Nine Mile Point
Nuclear Station

Subject: Nine Mile Point Unit 2
Docket No. 50-410 (License No. NPF-69)
Report of the Status of the Nine Mile Point Nuclear Station
State Pollutant Discharge Elimination System Permit (SPDES)

***Subject: Nine Mile Point Nuclear Station
SPDES Permit #NY0001015
SPDES Permit Modification Request***

SPDES Permit Modification Request

Nine Mile Point On-Site Map

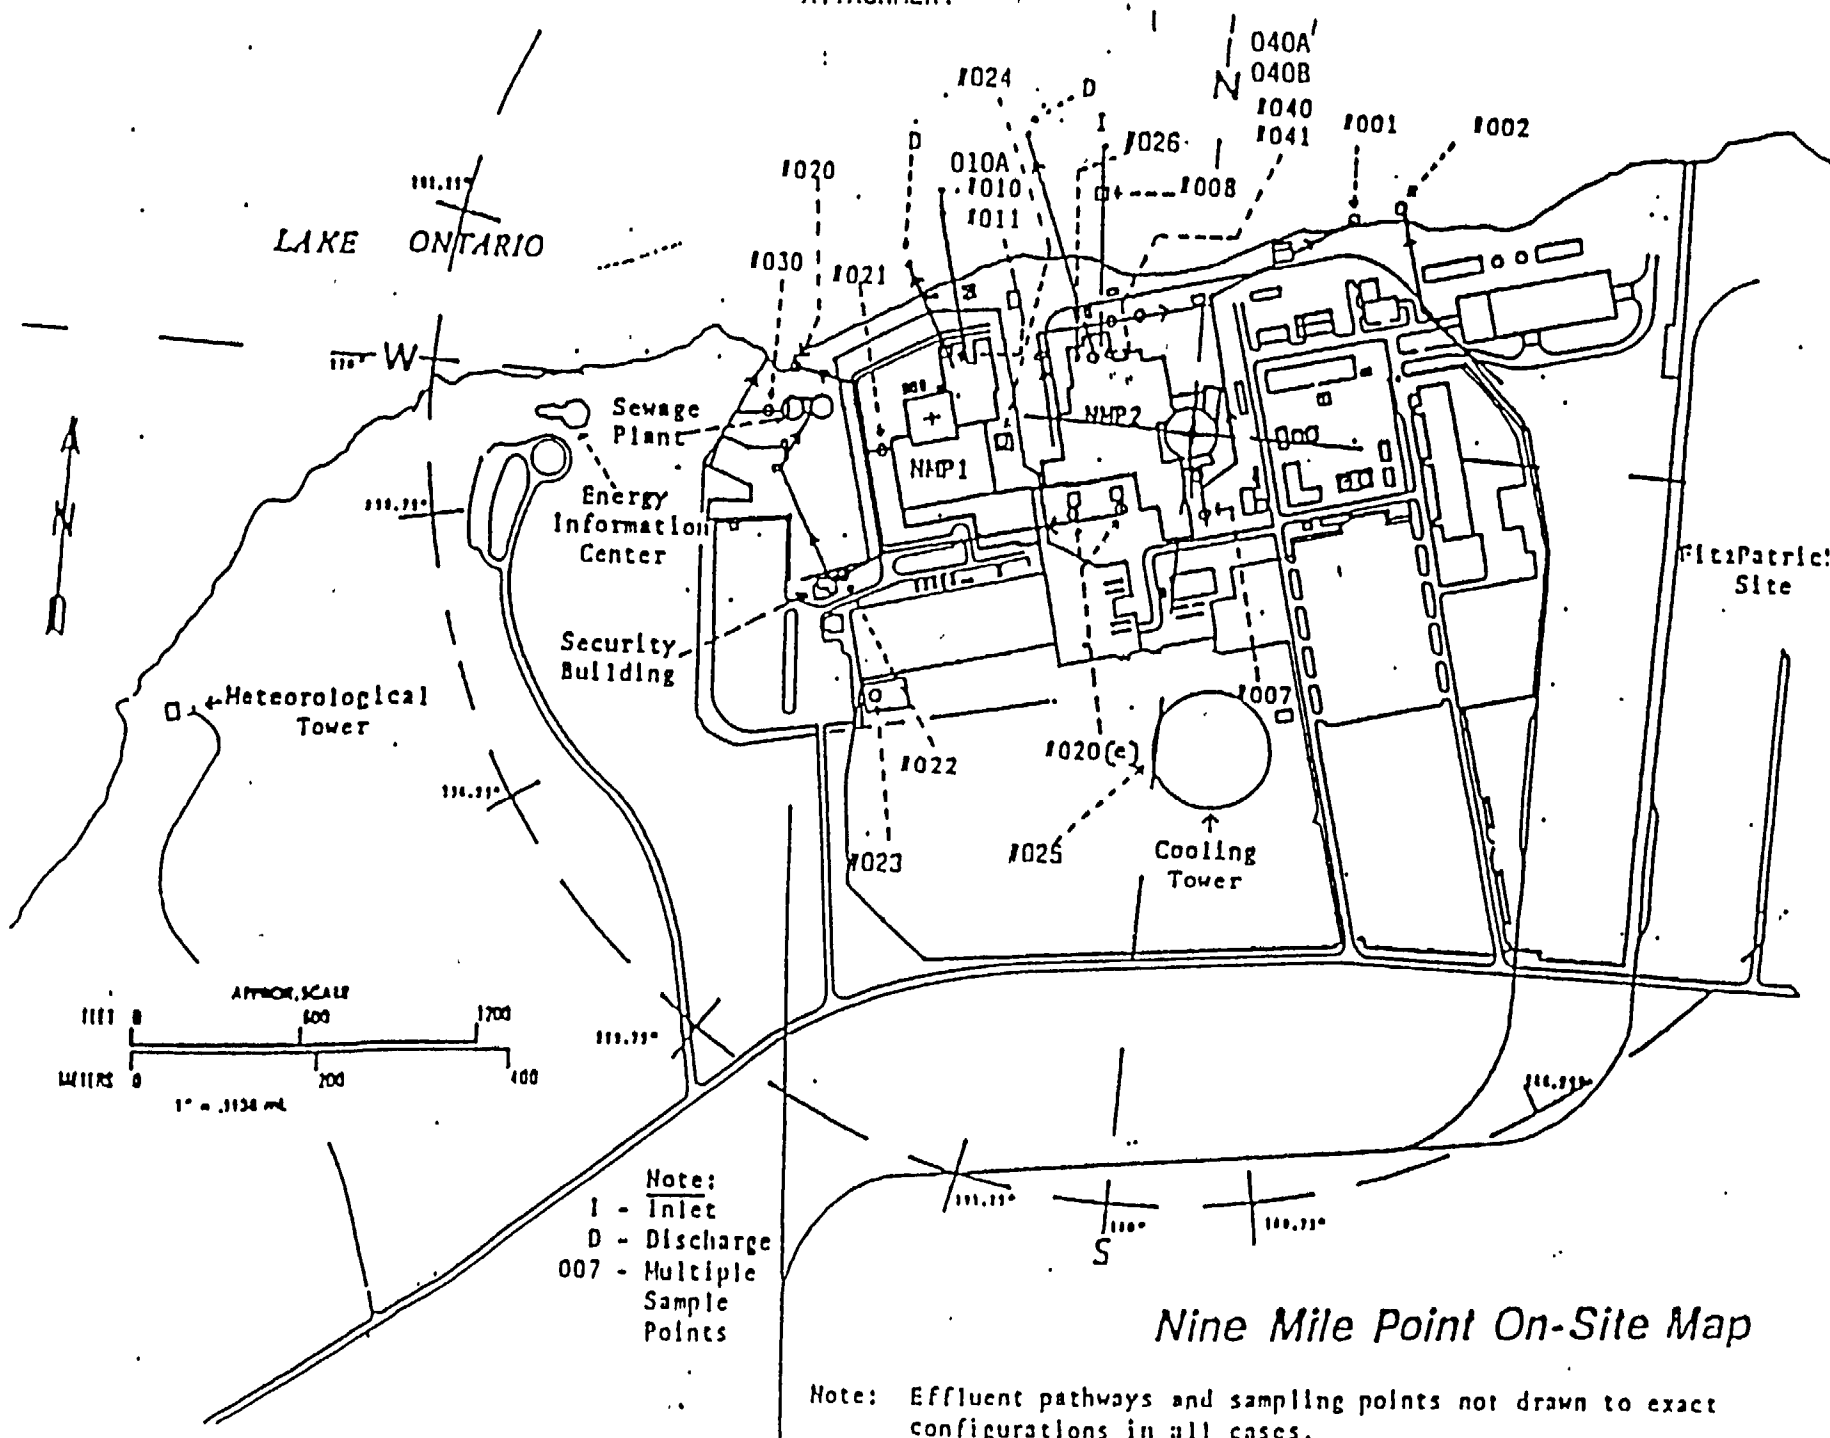
Discussion: The site diagram and monitoring locations schematic, Attachments 1 and 2 to the permit, respectively, have become difficult to read due to repetitive copying. In addition, changes reflecting the proposed modifications in this application are incorporated.

Request: Replace the current Attachments 1 and 2, pages 10 and 11 of 17, with the updated versions enclosed in this permit modification application [Attachments 9&10].

ATTACHMENT 2
Nine Mile Point Nuclear Station
Niagara Mohawk Power Corporation
Permit # NY 000 1015
Lake Ontario

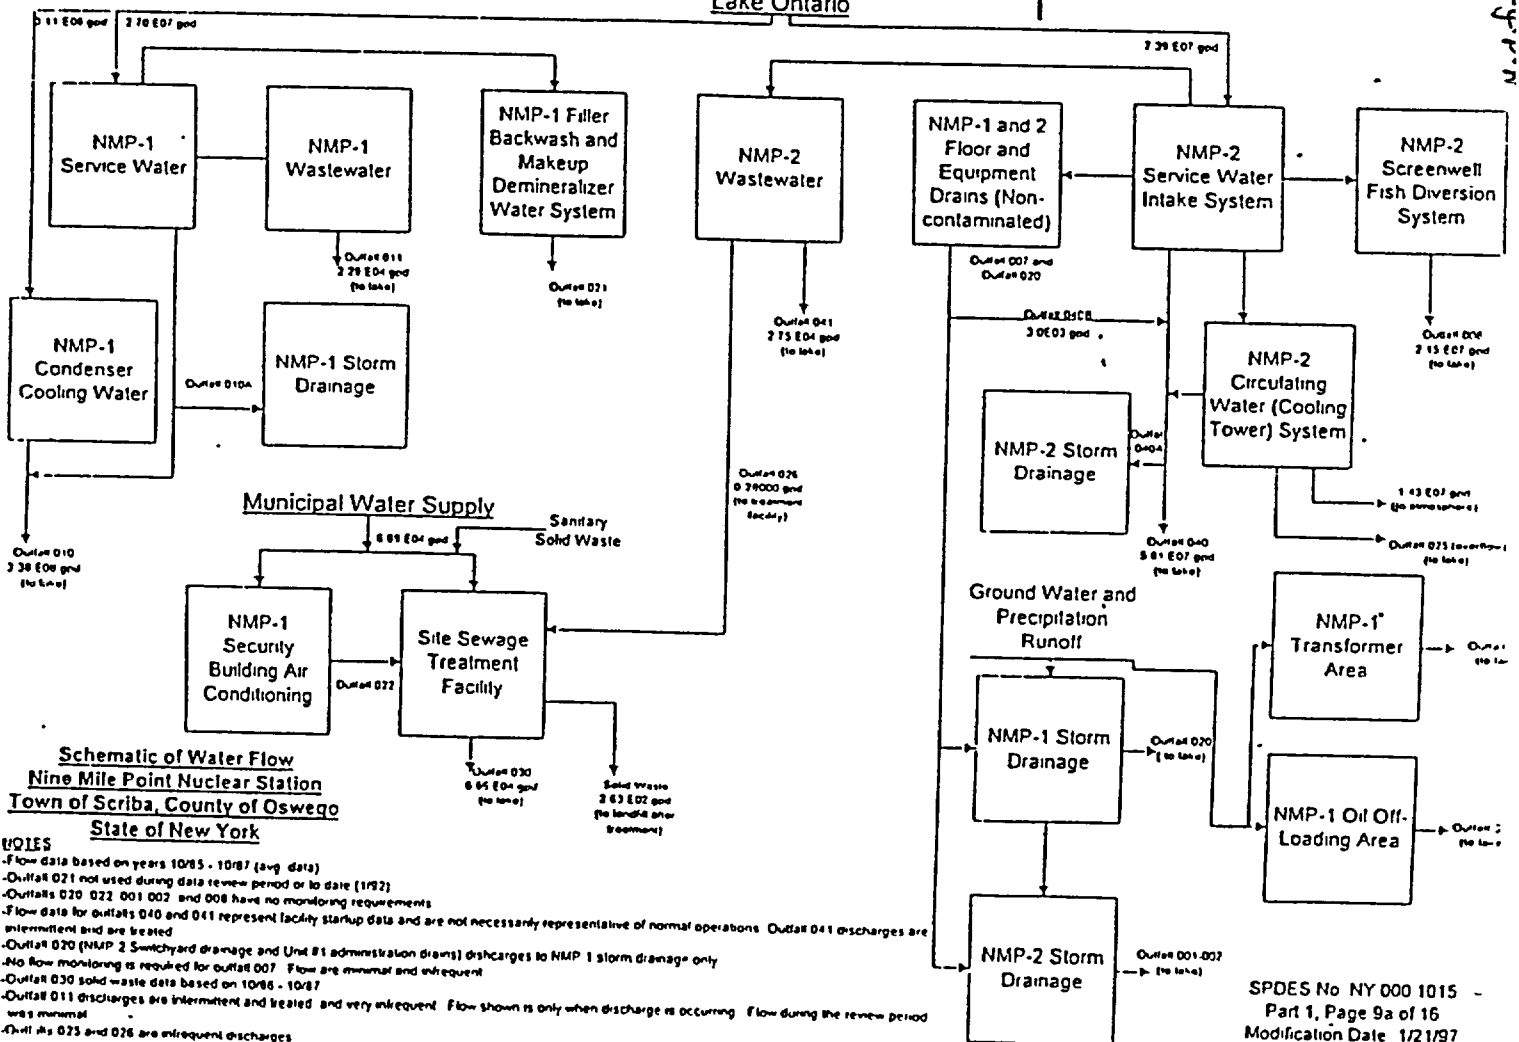
Request: Identify specific drains 007A through 007G on the permit monitoring location schematic as the contributing sources to Outfall 007. The permit monitoring location schematic is Attachment 2 in the permit (page 11 of 17 of the current permit). The existing permit parameters and limitations for the current Outfall 007 will apply to these newly designated locations. A proposed modification to the schematic is included as Attachment 10 to this application.

Request: Modify the permit monitoring location schematic (Attachment 2, page 11 of 17, in the permit) to allow Outfall 026 to discharge to Outfall 040 in addition to the currently permitted discharge to the Wastewater Treatment Plant (Outfall 030), i.e., either discharge location would be acceptable. When discharging to Outfall 040, effluent parameters of flow, pH and oil and grease would apply with quarterly monitoring requirements. The current discharge effluent parameter of flow would remain when discharging to Outfall 030. Attachment 10 of this modification is a revised monitoring location schematic incorporating these changes.

*Replace with
new flow chart
[Attachment 10]*
